**Center Leg Freeway  
"Return to L'Enfant"**

Case No. 08-34

**Statement of Monte Edwards  
December 6, 2010**

**Building Height, Area and Use Diagram**

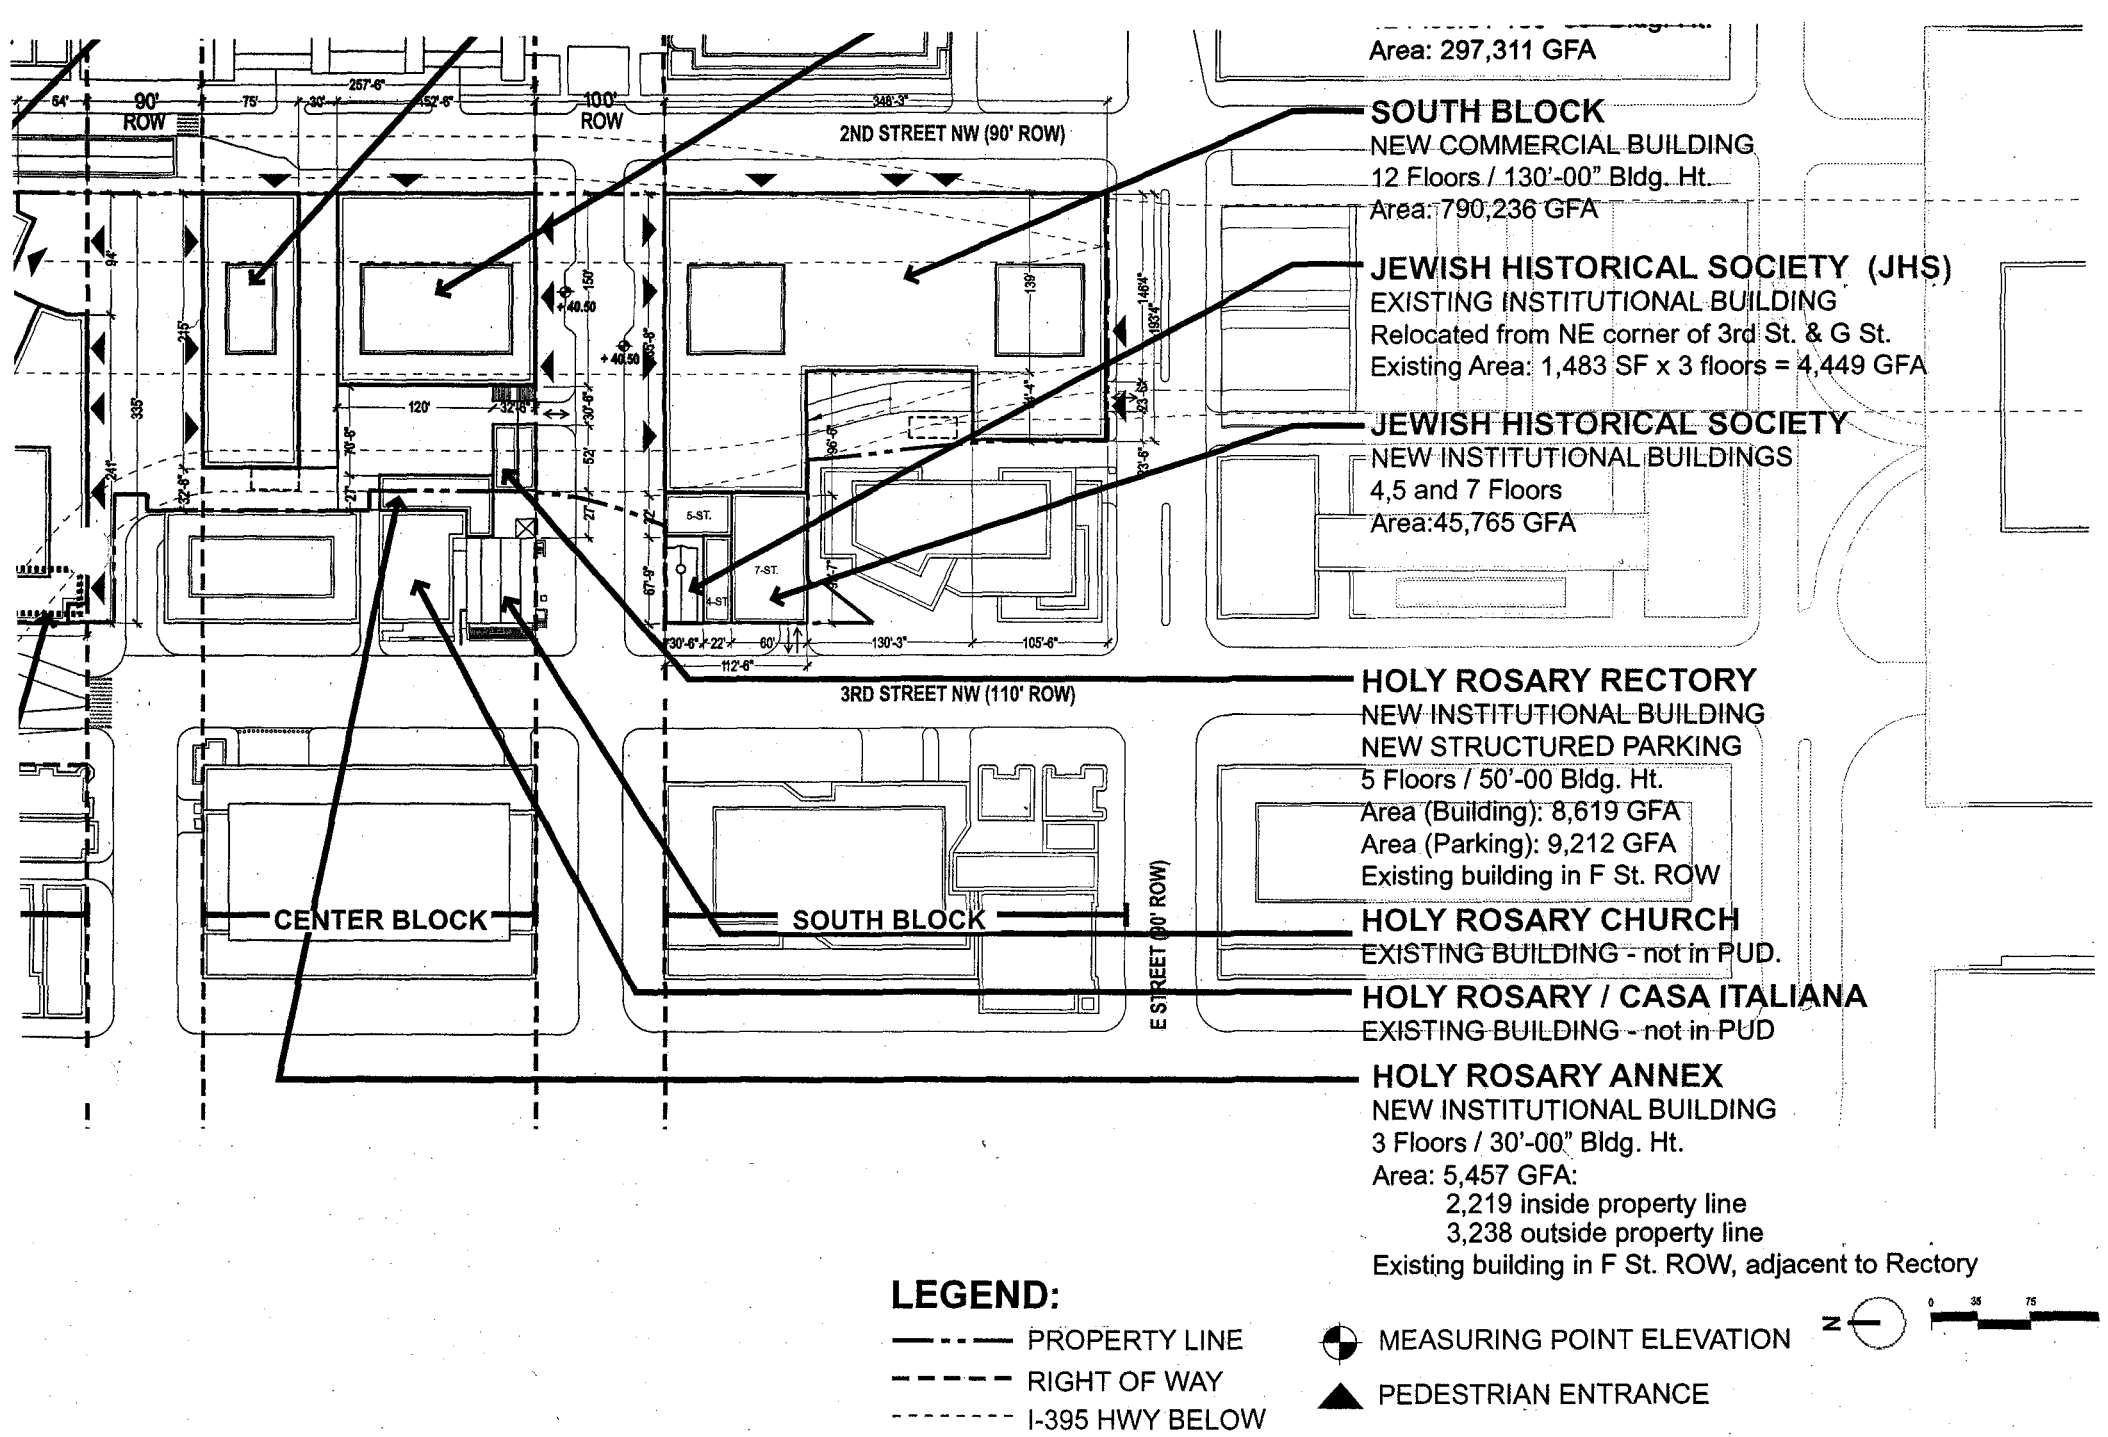
Likewise, the southern block (2nd-F-3rd-E streets) fronts on 2nd Street and E Street (except for a small protrusion on 3rd Street), both of which are 90 foot wide, and thus would also be limited to a 110-foot height. 3rd street NW is 110-foot wide and if the project faced 3rd Street, the middle and southern blocks could qualify for the 130-foot height. But Exhibit A, page 2.1, shows that in the middle block, the structures facing 3rd Street are:

- Holy Rosary Church, existing building, not in PUD
- Holy Rosary /Casa Italia, existing building, not in PUD

Apparently as part of the amenities, the developer is adding the Holy Rosary Annex and the Holy Rosary Rectory as additions to those existing structures. The applicant claims that while those existing buildings are not part of the PUD, they can be used to claim that this part of the project fronts on the 110 right-of-way of 3rd Street and thus justify a height of 130 feet.

In order for the center and south blocks to be considered a single structure (and hence allowing measurement of height from 3rd Street) they must be erected or maintained in single ownership. Nowhere in the application is there any indication that the applicant intends to own and then rent the Rectory and Annex space to the respective organizations.

Even if these existing buildings that face 3<sup>rd</sup> Street were “connected” or under common

ownership with the new structures, the definition of "Building, height of" states that whatever street you use for measurement must be selected as a street that the building fronts on:

If a building fronts on more than one (1) street, any front may be used to determine the maximum height of the building; but the basis for the height of the building shall be determined by the width of the street selected as the front of the building [emphasis supplied].

The front of a building typically has an entry and is the basis for determining the building address. Any buildings using 3rd Street for measurement purposes would thus have a front entry on 3rd Street and a 3rd Street address. The first paragraph of Section 5 of the Height Act specifies the maximum "height above of the sidewalk the width of the street, avenue or highway in its front, increased by twenty feet [emphasis supplied]."

Reading these together, the width of the street in front of the main building is determinative, not the street on which the two existing buildings that are being modified a part of the amenities are located.

The other issue is the measuring point the applicant has a proposed for the middle and southern blocks of the development: the yet-to-be constructed bridge or platform that will reconnect 2nd and 3rd streets. Normal practice is to measure from natural grade, and both 2<sup>nd</sup> and 3rd streets are "at natural grade". There is no discernable advantage in terms of increased height in specifying the yet-to-be-constructed platform as the measuring point. It would not reduce the height of the project if the existing curb of 2nd Street, or 3<sup>rd</sup> Street were specified as the measuring point for the middle and southern blocks of the project.

But to depart from the long-standing practice of measuring from natural grade and allow the measuring point to be a man-made platform introduces a new and potentially troublesome concept. What happens if a higher platform is introduced, such as what is proposed for the Union Station air rights development? If such a platform is 30 feet above natural grade and that is used for the measuring point to apply the Height Act maximum height of 130-feet, the result will be a towering 160-foot project (with yet another 18 ½ feet for the penthouse).
